**CONSENT DECREE WITH  
NCR CORPORATION AND GEORGIA-PACIFIC CONSUMER PRODUCTS LP  
REGARDING PARTICULAR REMEDIAL ACTION WORK TO BE PERFORMED AT  
THE LOWER FOX RIVER AND GREEN BAY SUPERFUND SITE IN 2015**

Re: Notice of Approval with Modifications, 2015 Remedial Action Work Plan  
Administrative Order for Remedial Action ("UAO"), Docket No. V-W-'08-C-885  
Lower Fox River and Green Bay Superfund Site, WI

**FINAL PHASE 2B WORK PLAN FOR 2015 REMEDIAL ACTION  
OF OPERABLE UNITS 2 THROUGH 5**

Figure 5-1. Preliminary 2015 LFRR Processing Facility - Site Layout

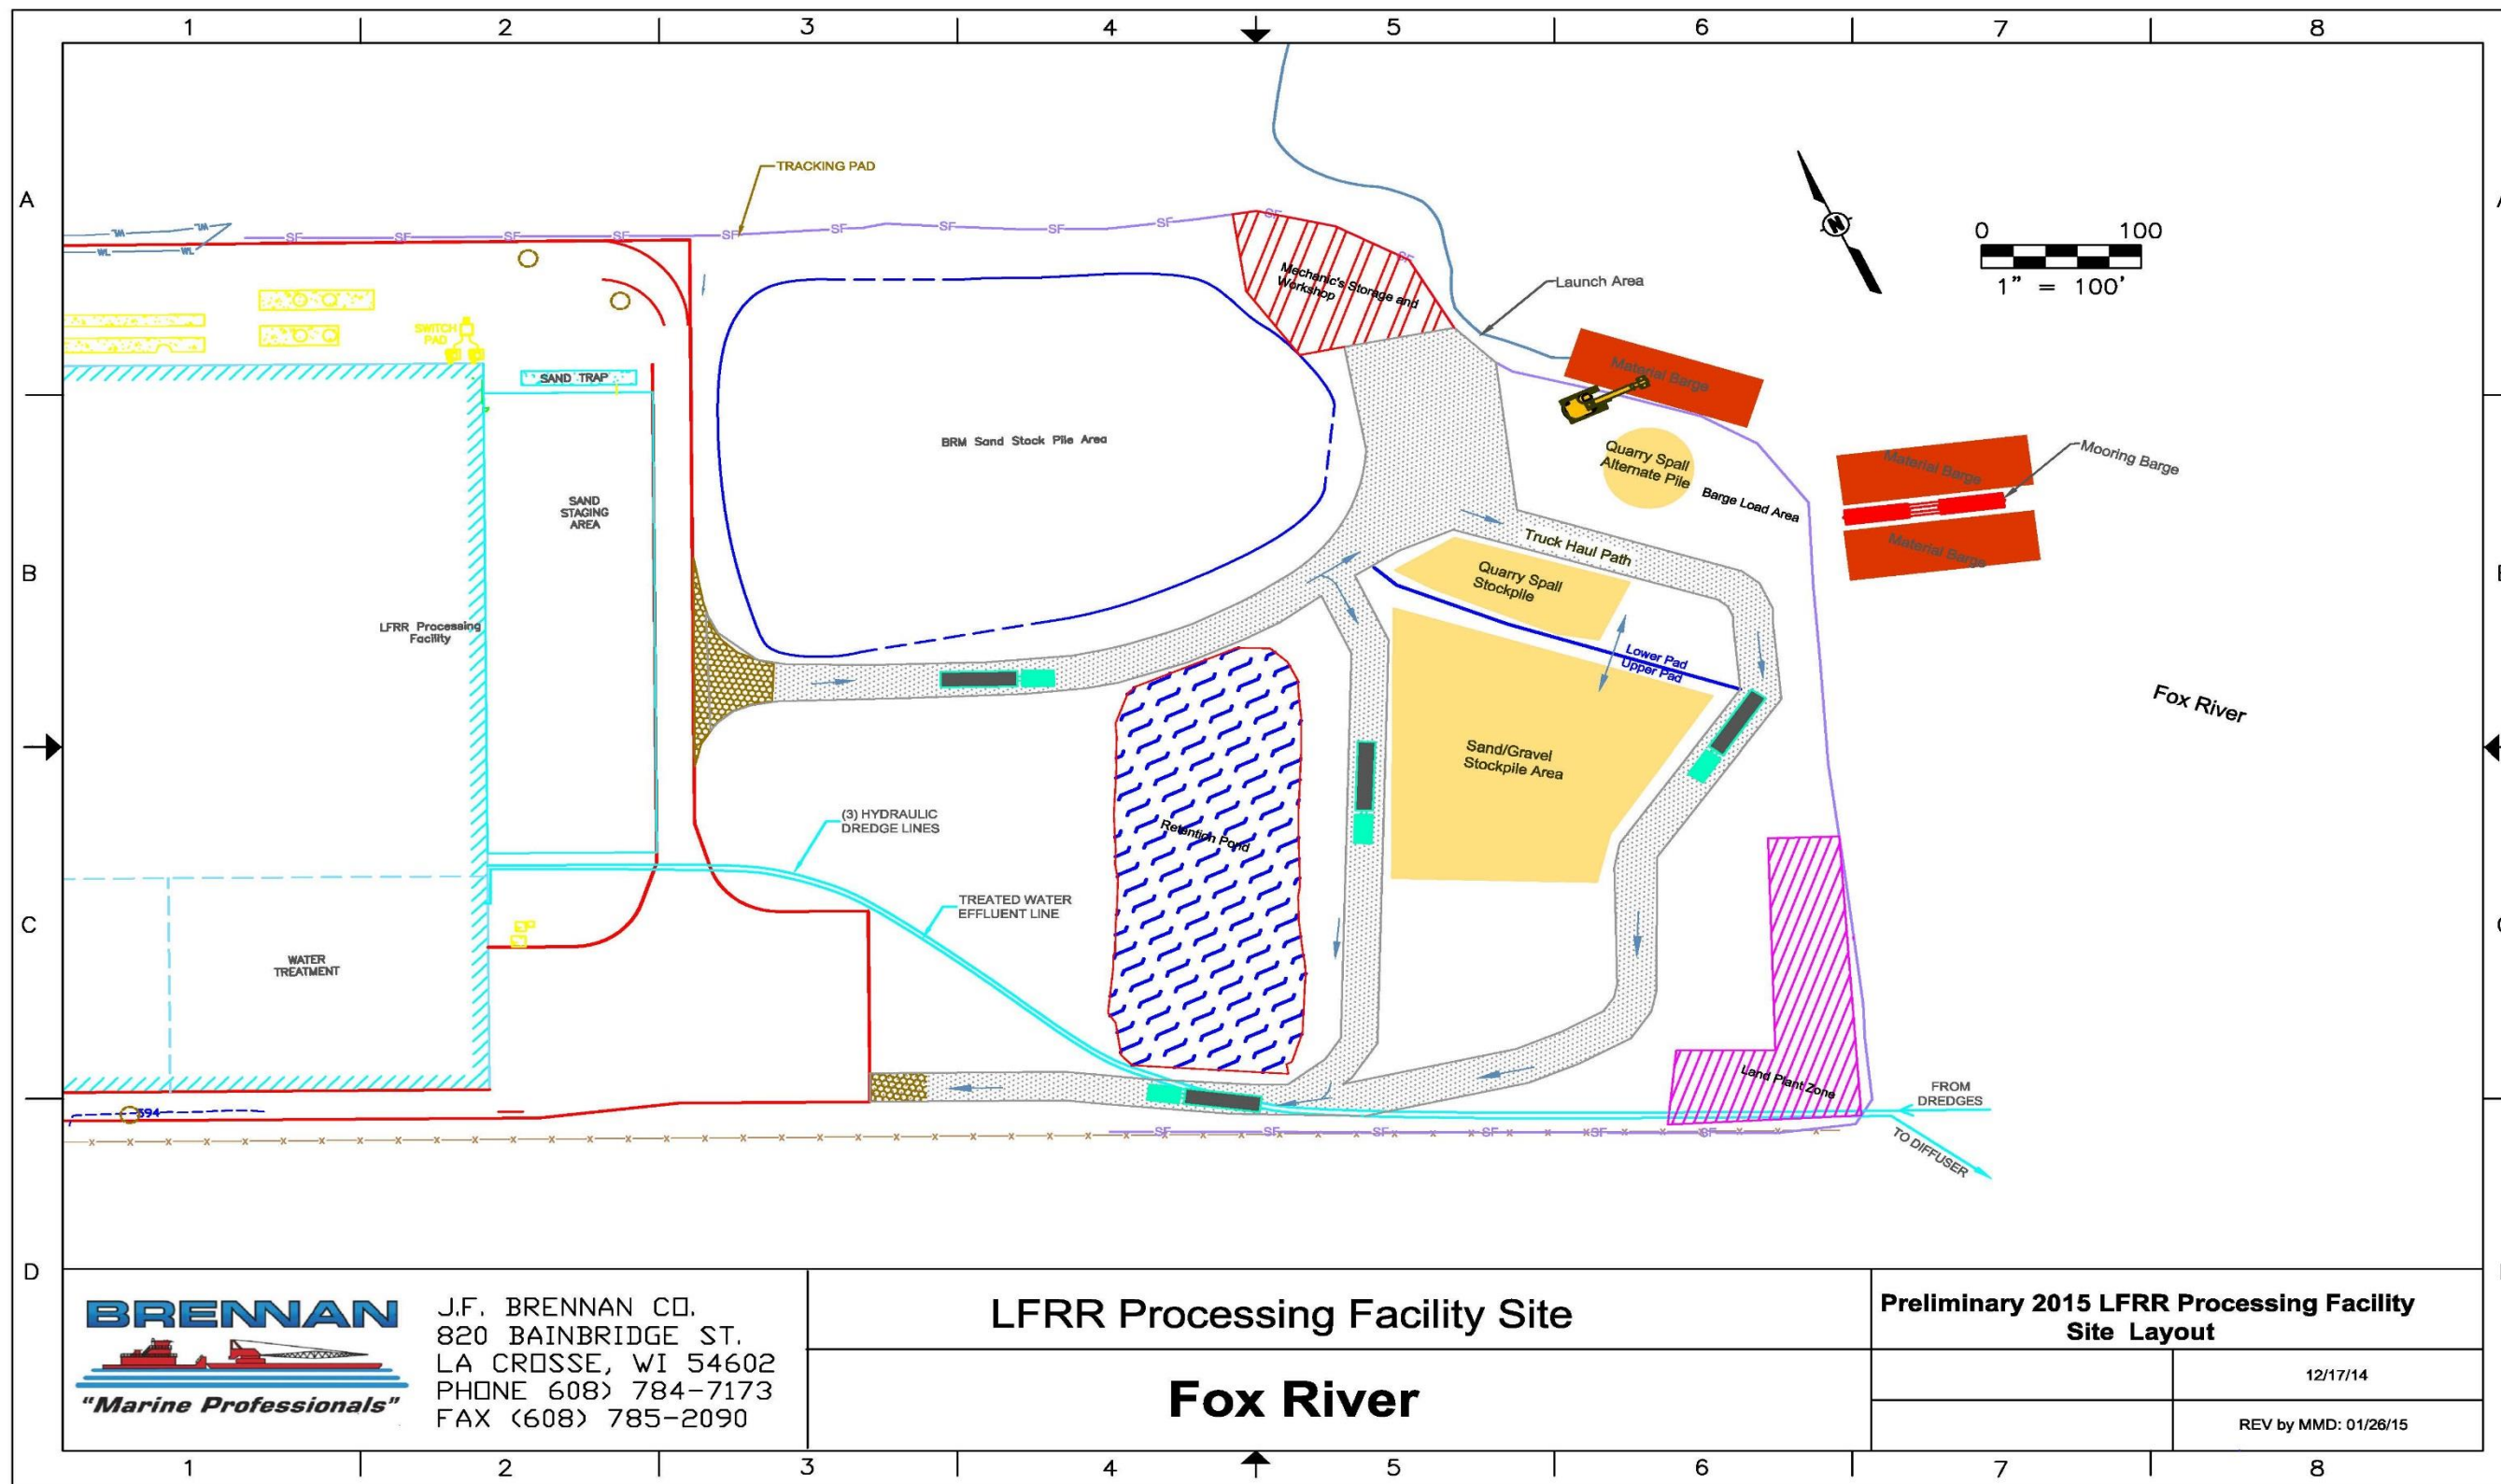
19. A/OT Comment 2015-02-05: Arrange a work group to review Figure 5-1 in order to discuss how this area is operated.

A/OT Comment 2015-04-08: The response is acceptable but the over-the-shoulder work group meeting still needs to be held. Conduct the OTS and resubmit an updated Figure 5-1.

Figure 9-1. Phase 2B Remedial Action Schedule for 2015

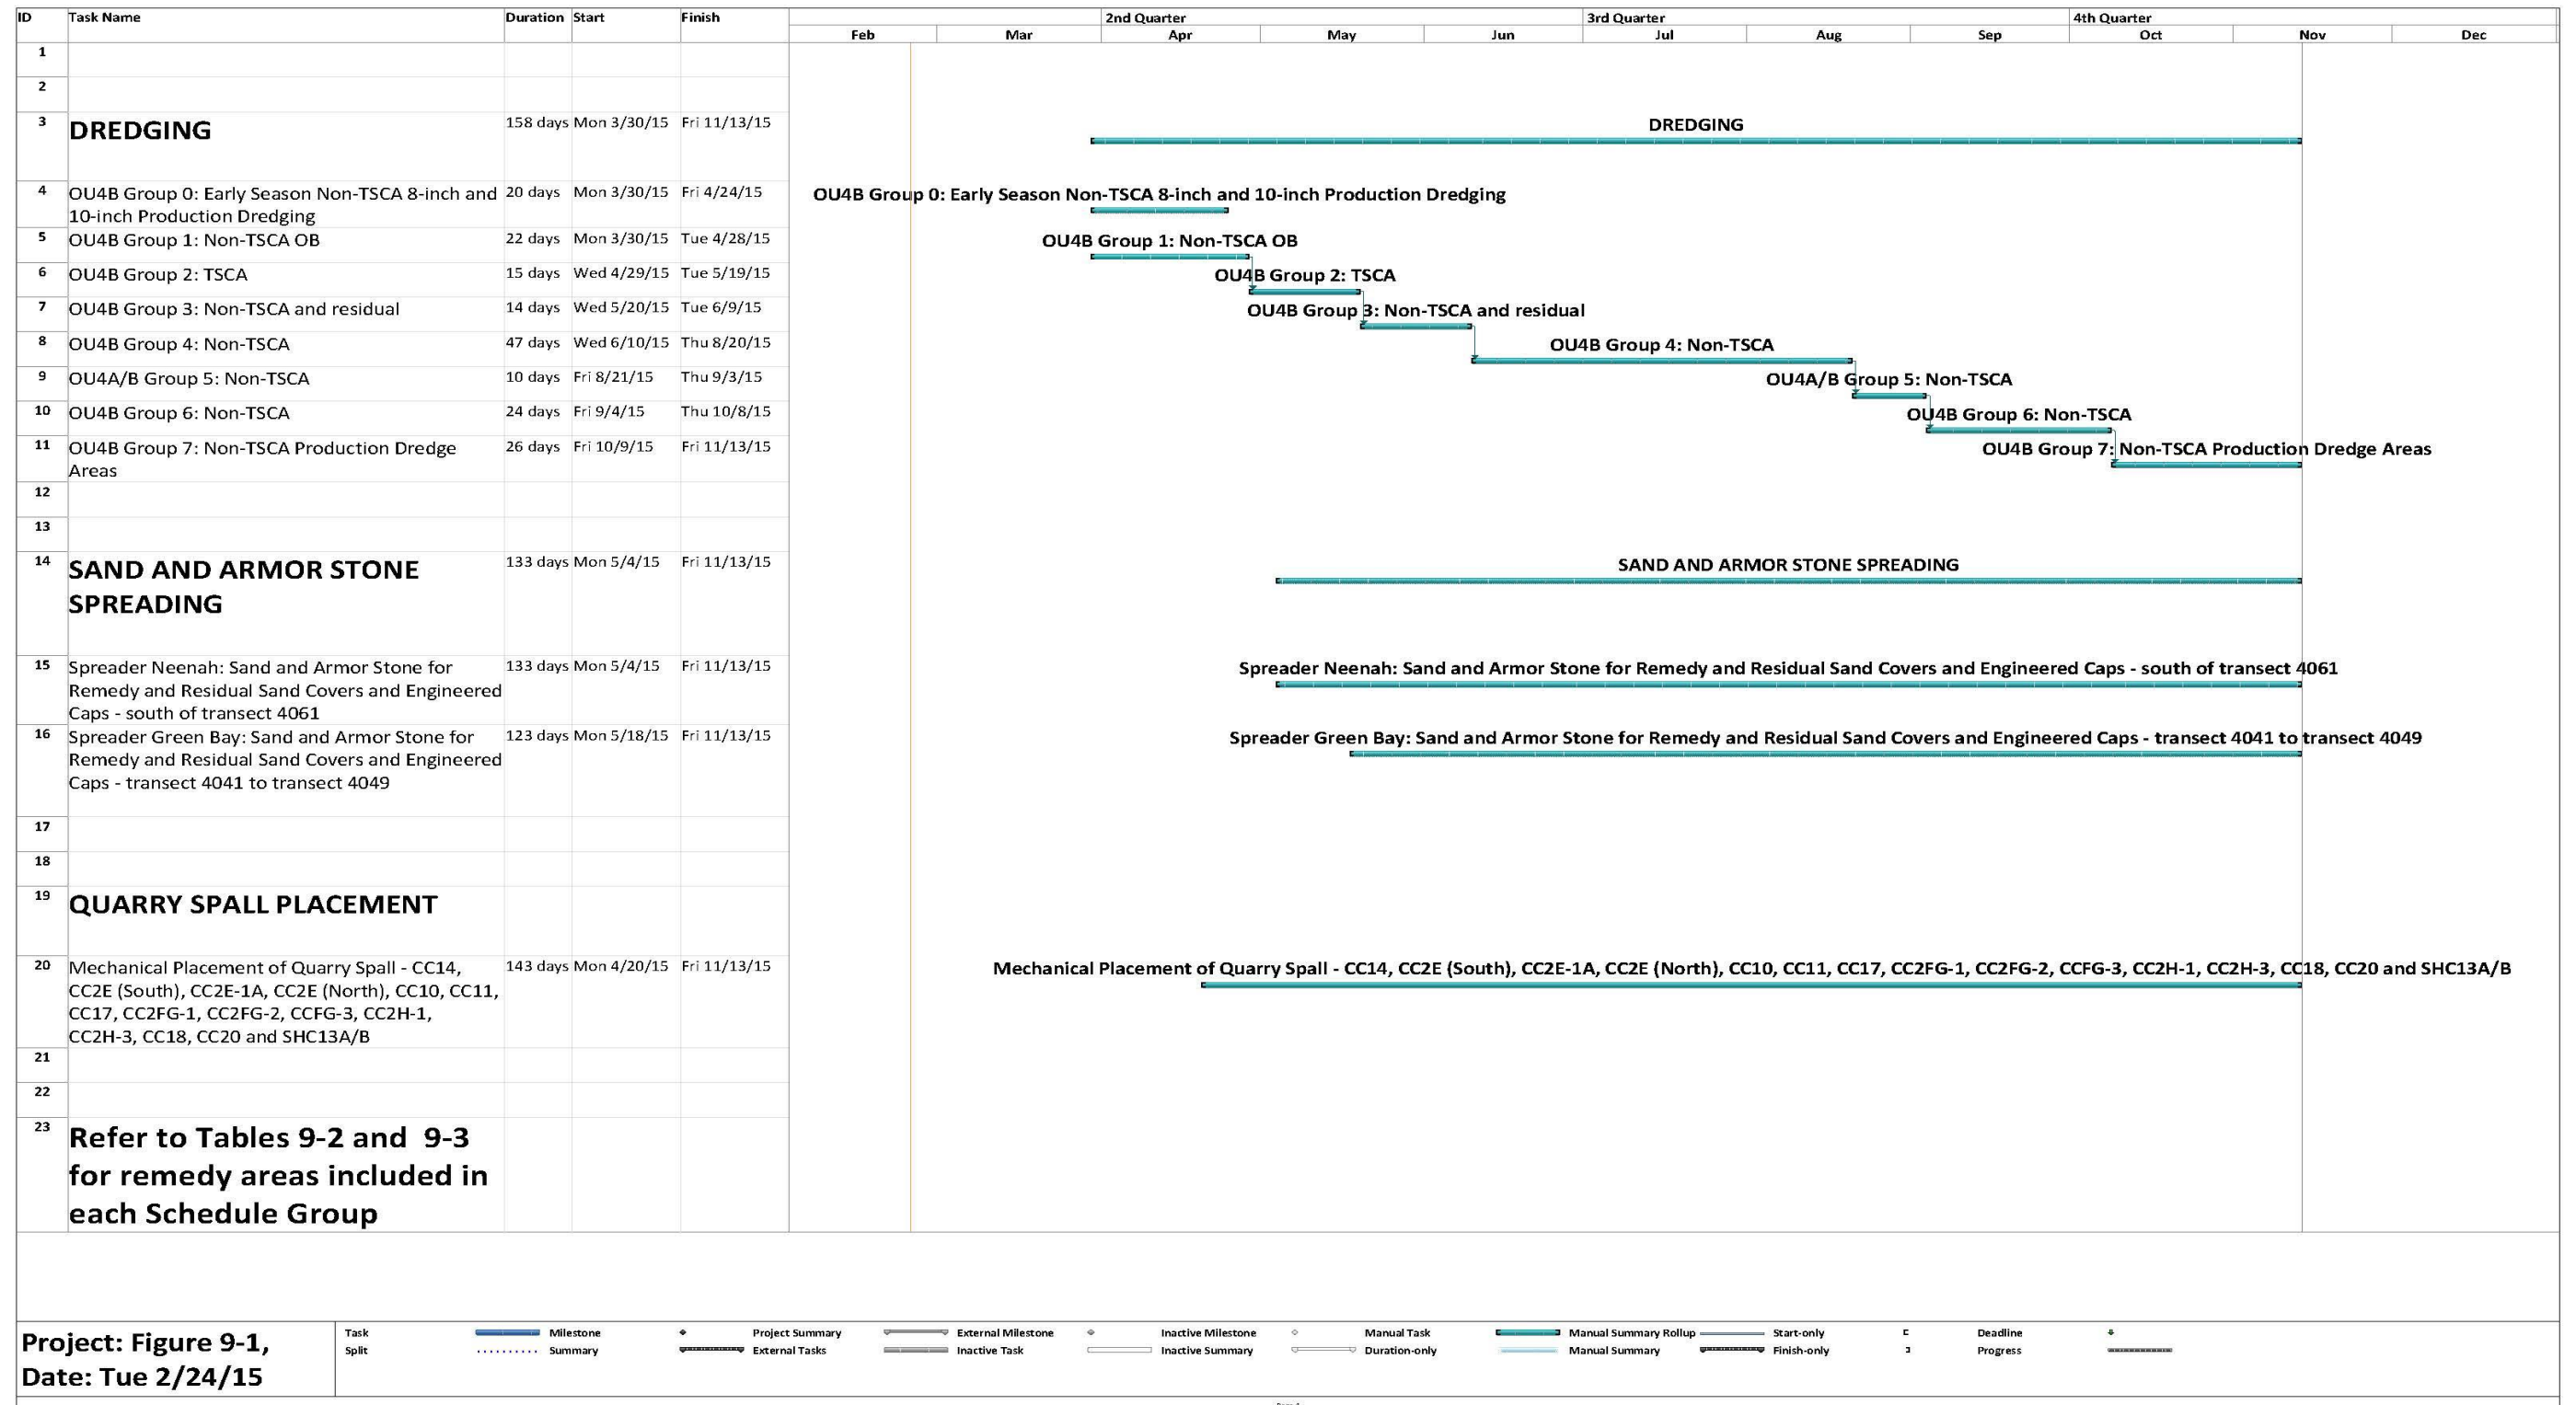
23. A/OT Comment 2015-02-05: Section 9, Figure 9-1 Schedule – Previous schedule figure included monthly time columns, this version only shows quarters. Please restore the monthly columns.

25. A/OT Comment 2015-02-05: Section 9, Figure 9-1 Schedule – Previous Schedule has a footnote on the bottom of the page referencing page 9-5 for area groupings. This is now missing. Please insert reference for the schedule groupings. (i.e.: page 9-6)

28. A/OT Comment 2015-02-05: Section 9, Figure 9-1 Schedule – Line 21, Quarry Spall Placement: The areas listed do not include all the areas listed in Table 5-4, delete the areas listed and list similarly to the description on page 9-6.

**LLC Response 2015-02-27: Figure 9-1 has been revised to include months along the time scale.**

**LLC Response 2015-02-27: Figure 9-1 has been revised to add a footnote referencing Tables 9-2 and 9-3 for the area groupings.**

**LLC Response 2015-02-27: Quarry spall placement plans for the 2015 season have been updated on Figure 9-1.**

**LLC Response 2015-02-27: The areas listed for quarry spall placement planned in 2015 have been revised in Table 5-4. Figure 9-1 has also been revised to include all the areas listed in Table 5-4 and shown in the quarry spall grouping in Table 9-3 on page 9-6.**
